ADDENDUM NO. 3 - TO ALL PLAN HOLDERS OF RECORD

Maine-Endwell Central School District
2022 Capital Improvement Project – Phase 5
Homer Brink Elementary– SED # 03-11-01-06-0-001-023

King + King Project #23-44-7956

AD3-A.01

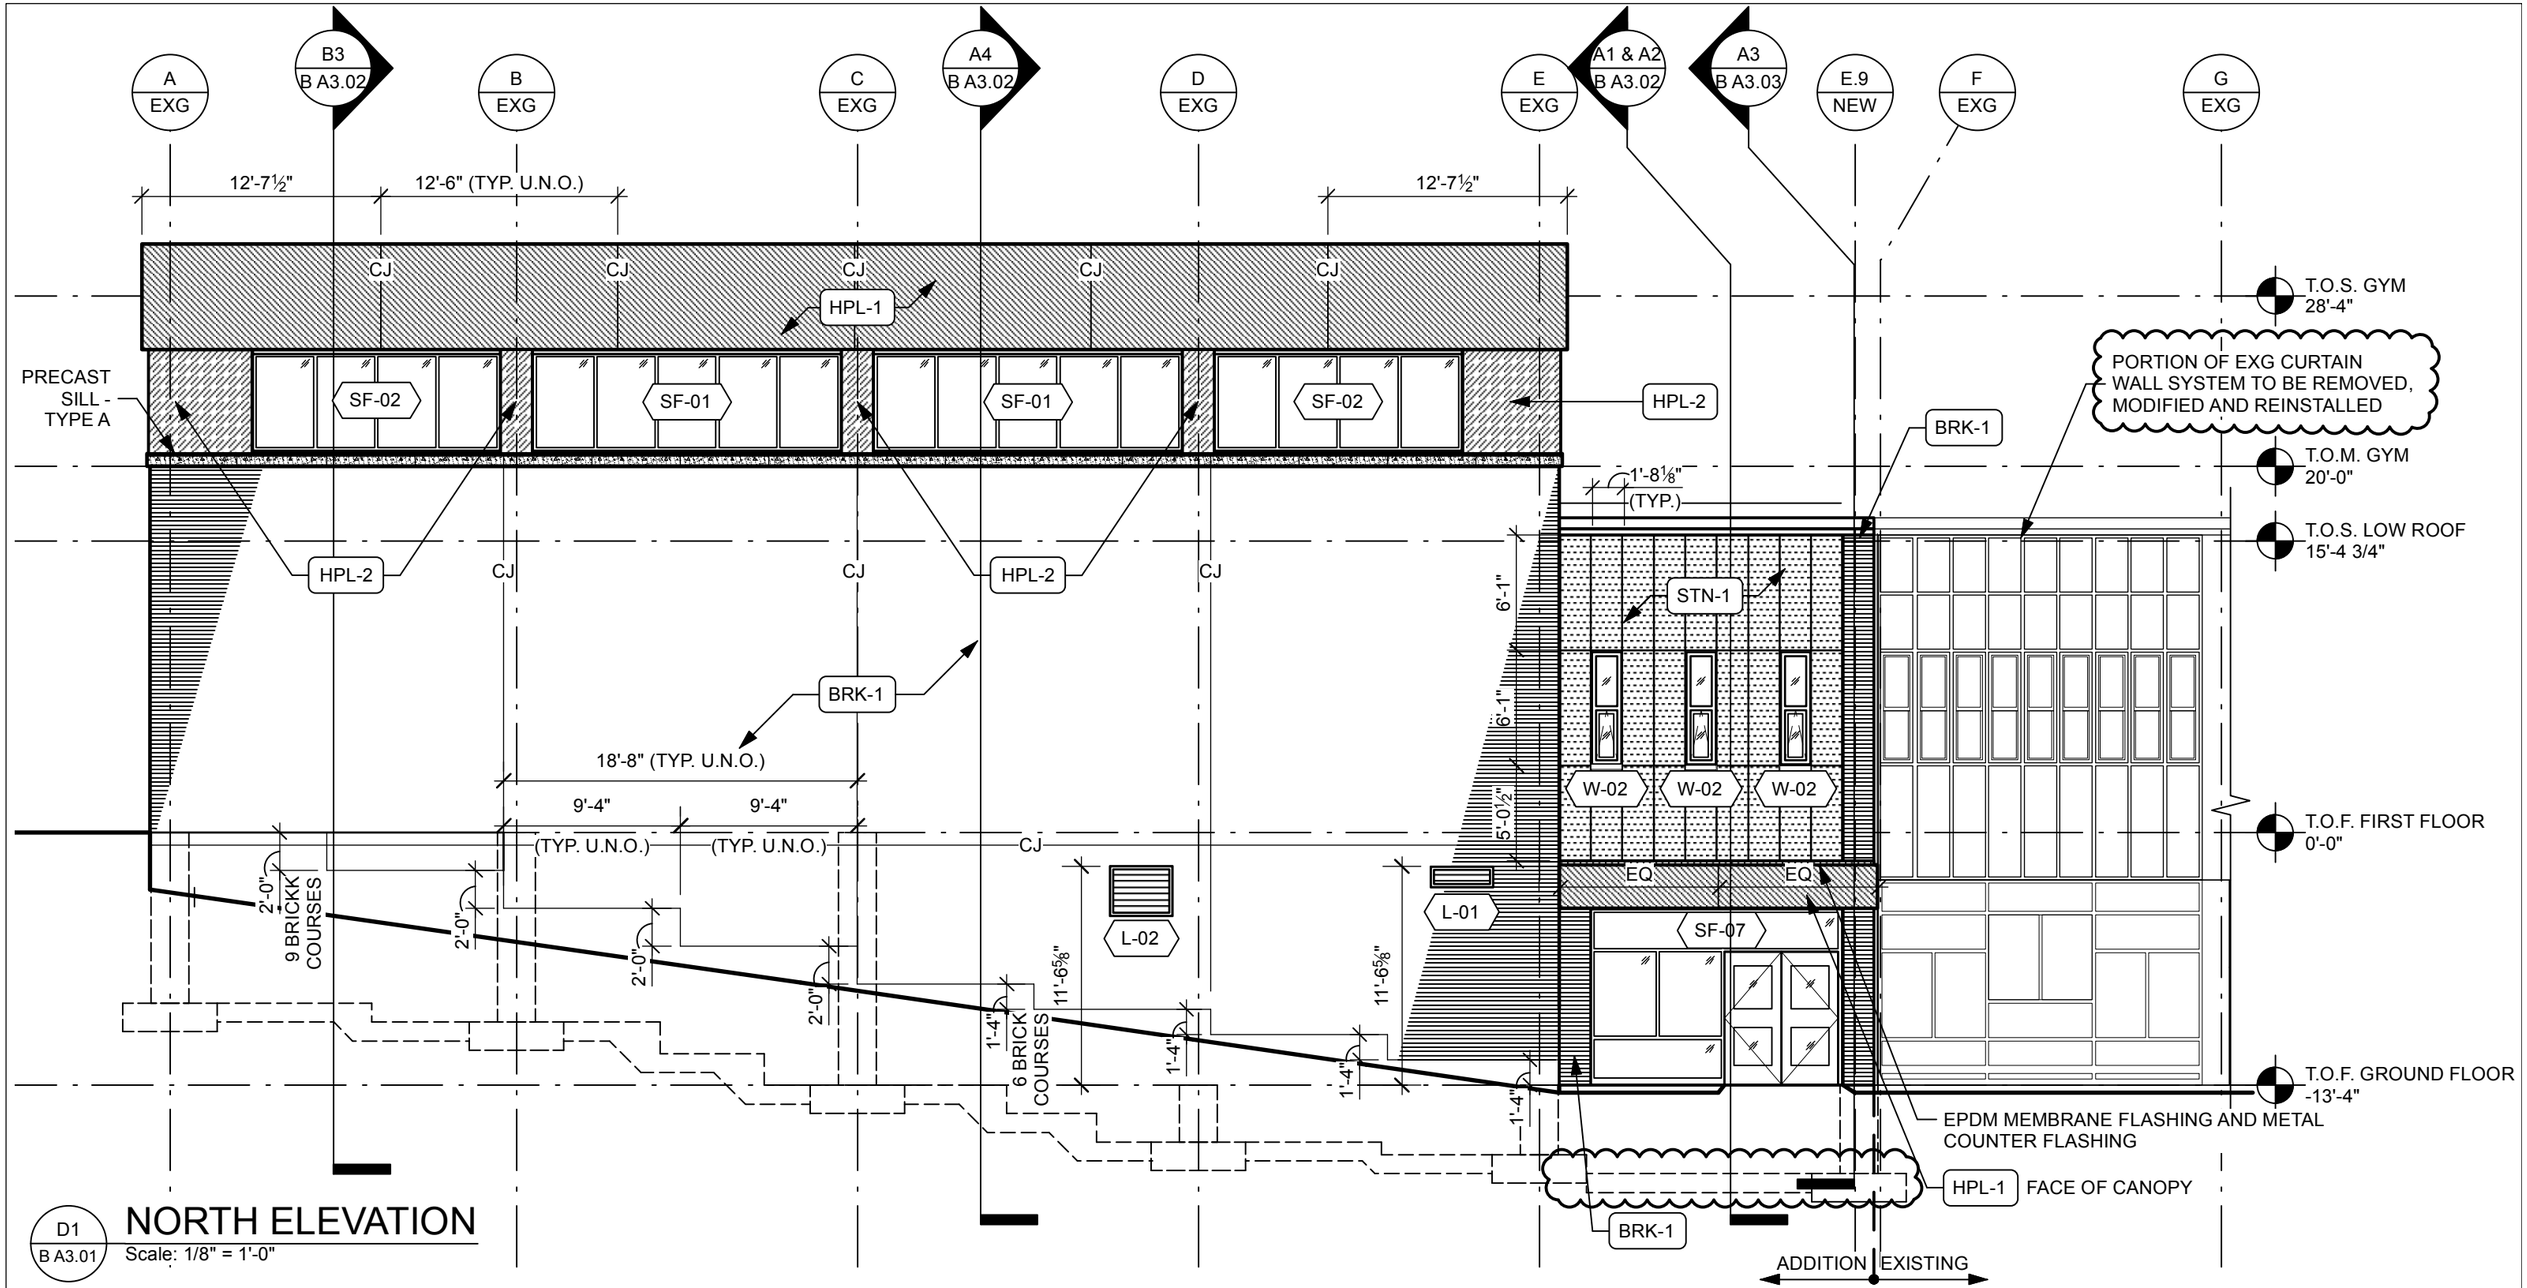
a. Refer to D1 / NORTH ELEVATION and **REPLACE** with D1 / NORTH ELEVATION as shown in AD3-A.01 attached to this Addendum.

b. Note: The foundation footing between Column Lines Exg-E and New-E.9 was modified to eliminate the footing step. The callout note with information about the existing curtain wall system was modfied.

1 ST0.01 PARTIAL FIRST FLOOR DEMOLITION PLAN

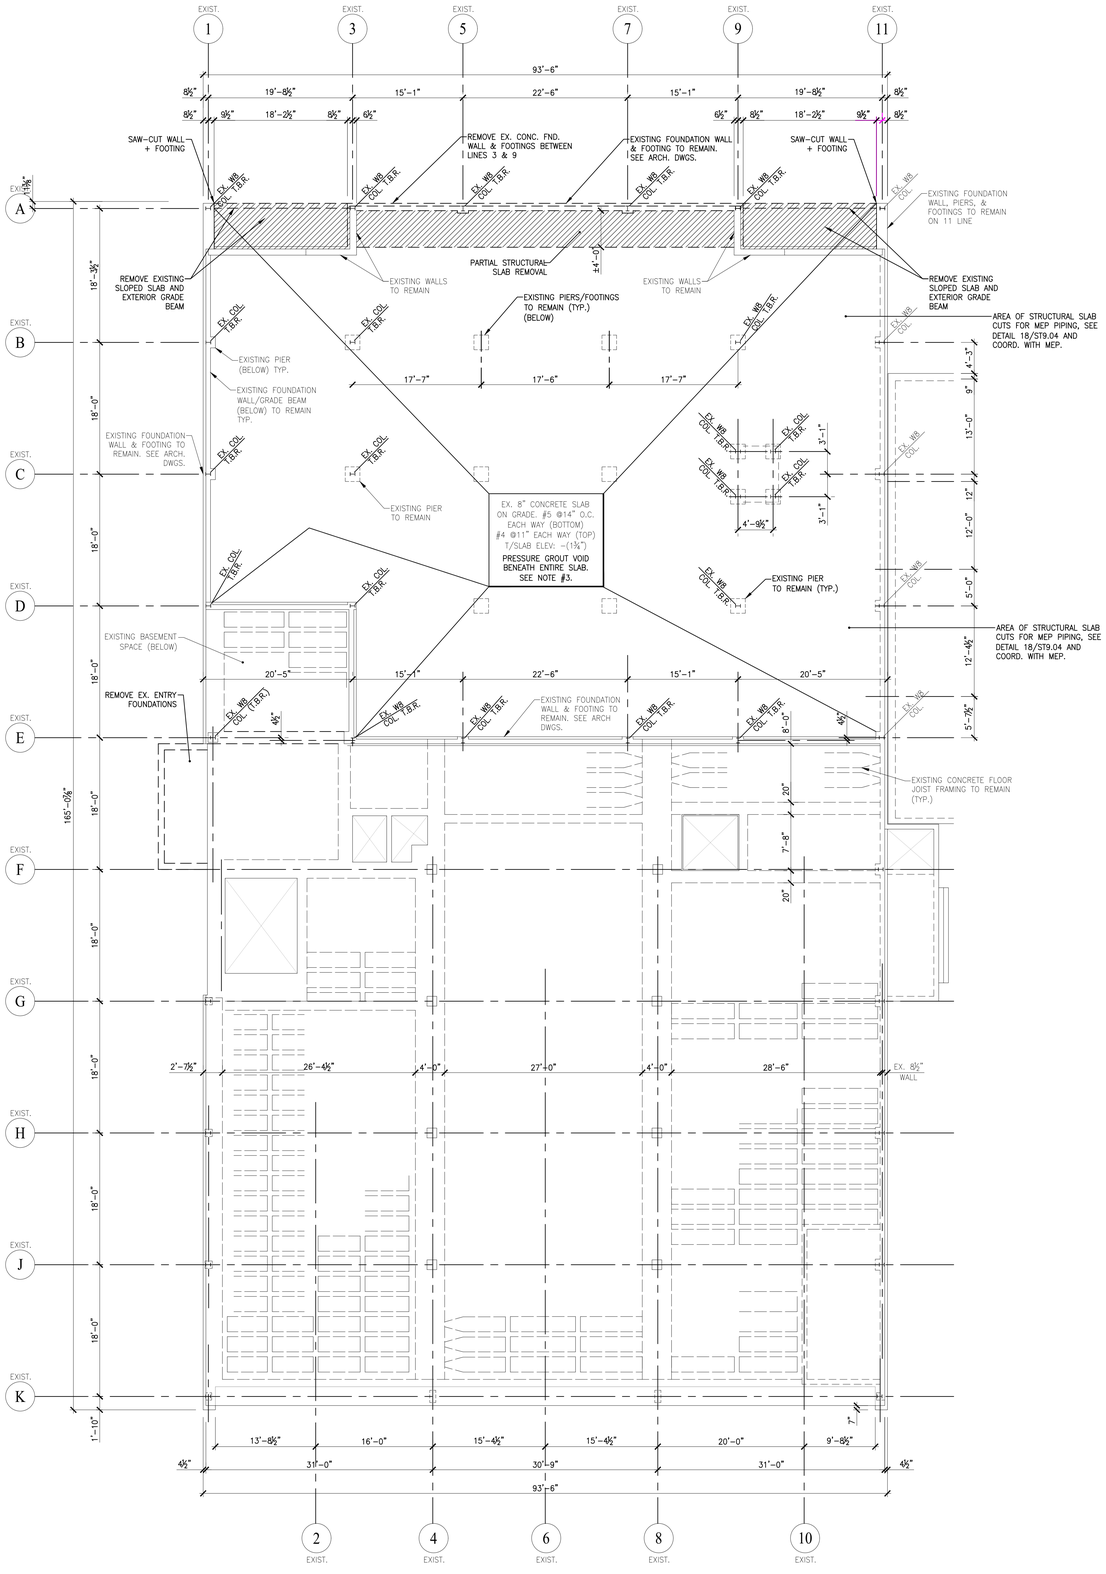
a. **REPLACE** this sheet in its entirety with B/ST0.01 – PARTIAL FIRST FLOOR DEMOLITION PLAN attached to this Addendum.

b. Note: The notes regarding the pressure grouting have been revised.

3. PRESSURE GROUTING:
   PRESSURE GROUT THE VOID BENEATH THE EXISTING 8" STRUCTURAL SLAB AT GRADE. BASED ON FIELD MEASUREMENTS, ASSUME VOID UNDER SLAB IS 6" EVERYWHERE. CONTRACTOR SHALL SUBMIT ENGINEERED GROUTING PLAN AND MIX DESIGN FOR INSTALLATION OF THIS GROUT FOR REVIEW + APPROVAL. THE GROUTING INSTALLATION MUST OCCUR BEFORE THE START OF DEMOLITION. USE A FINE GROUT WITH MIN. STRENGTH OF 3,000 PSI AND HIGH SLUMP FOR PUMPING.

1 ST1.02 PARTIAL FIRST FLOOR FRAMING PLAN

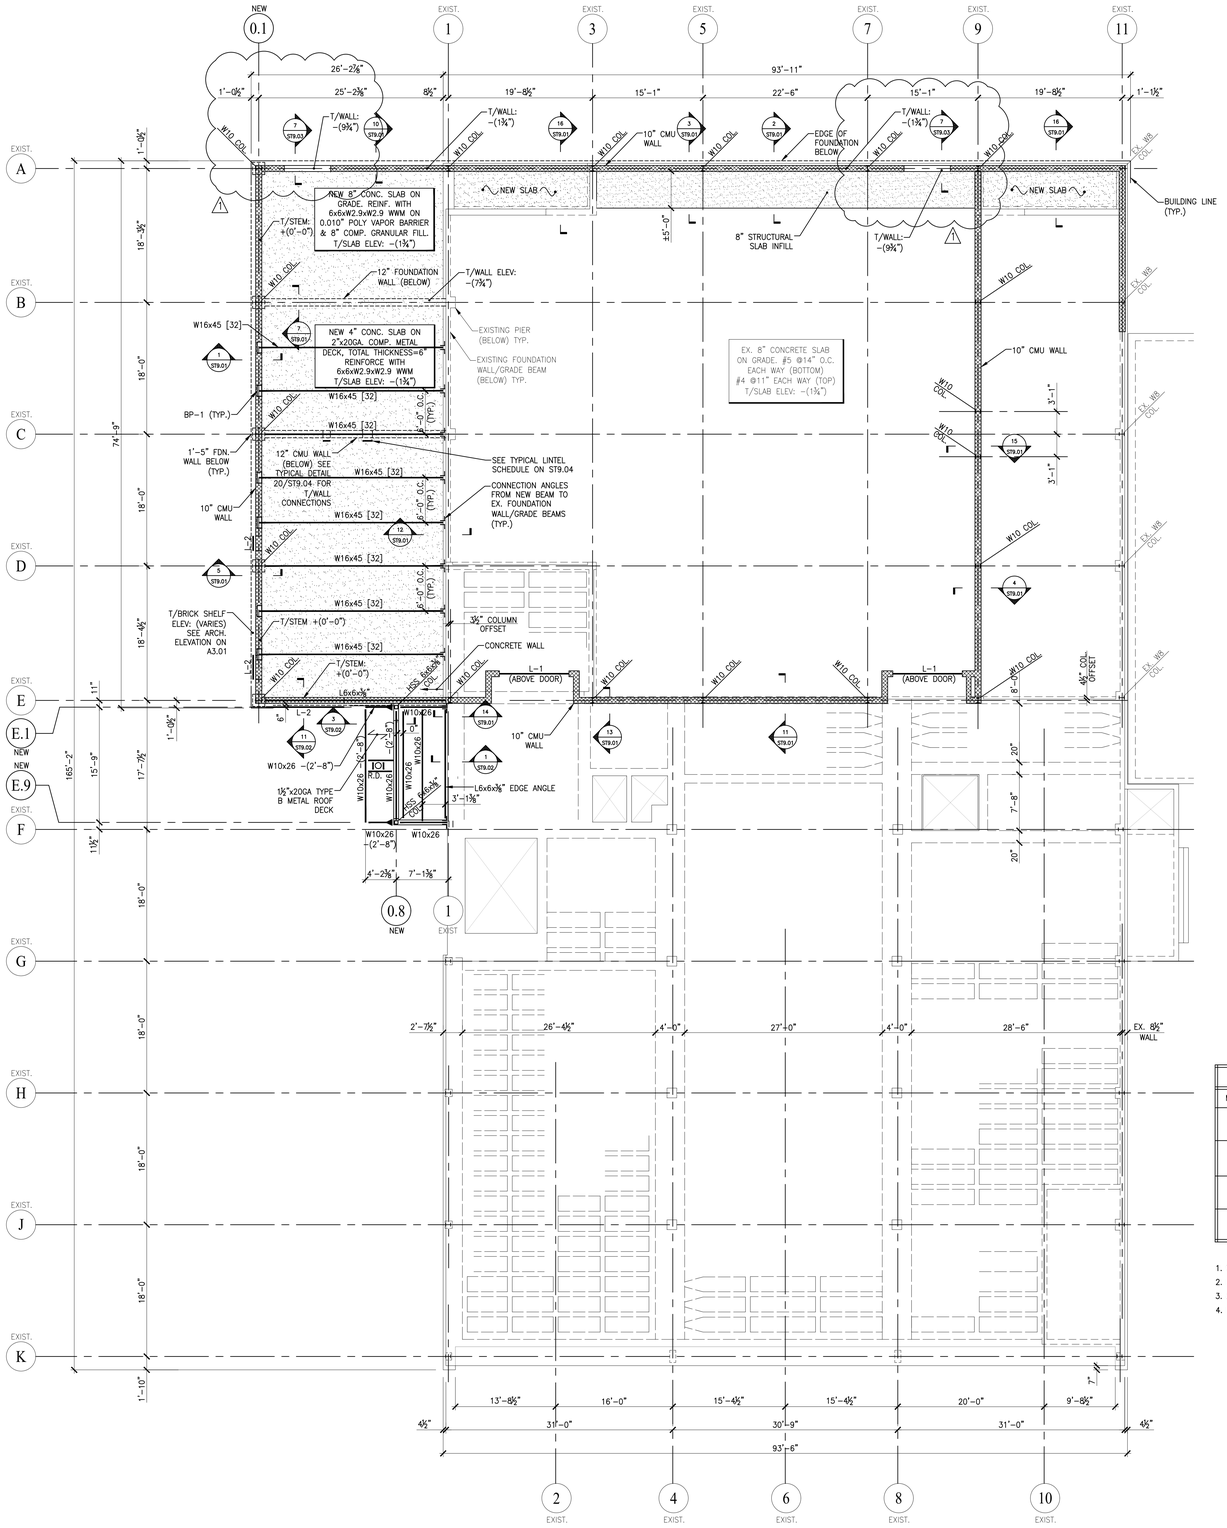
a. **REPLACE** this sheet in its entirety with B/ST1.02 – PARTIAL FIRST FLOOR FRAMING PLAN attached to this Addendum.

b. Note: The detail callout at the foundation wall beneath the Exterior Gymnasium Door Openings has been revised.

7 ST9.03 FOUNDATION SECTION AT GYM EXTERIOR DOORS
SCALE: 3/4"=1'-0"

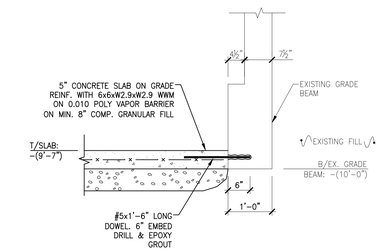
a. **REPLACE** this sheet in its entirety with B/ST9.03 – SECTIONS & DETAILS attached to this Addendum.

b. Note: A detail illustrating the foundation condition at the Exterior Gymnasium Door Openings has been added to the drawing.
